RE: Request for Additional Information Related to the Certificate of Compliance No. 9290
MDS Nordion's Model No. F-430 and Certificate of Compliance No. 9310, MDS
Nordion's Model F-431

Attached: ASSESSMENT OF F-430 TIE-DOWN COLLAR BOLTED CONNECTION

Figure 1: Tension on Tie-Down Collar

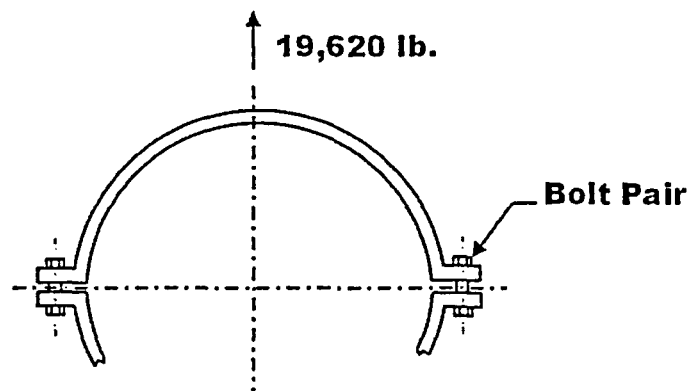
This letter is in response to the U.S. Nuclear Regulatory Commission's (NRC) Request for Additional Information (RAI) dated July 22, 2004. The additional information requested relates to the need for an analysis of the bolt stresses considering the gap in the tiedown collar joint. Please find attached a report, which analyses the bolt stresses in the tiedown collar joint.

The component of the horizontal tie-down force acting in the direction of the axis of the bolts applies tension on the bolts. As a worst-case condition, the entire horizontal tie-down force is considered to act along the axis of the bolts (see Figure 1).

$$\sigma_t = F_t/A_t = 19,620/1.725 = 11,374 \text{ psi}$$

$$SF_t = \sigma_y/\sigma_t = 80,000/11,374 = 7$$
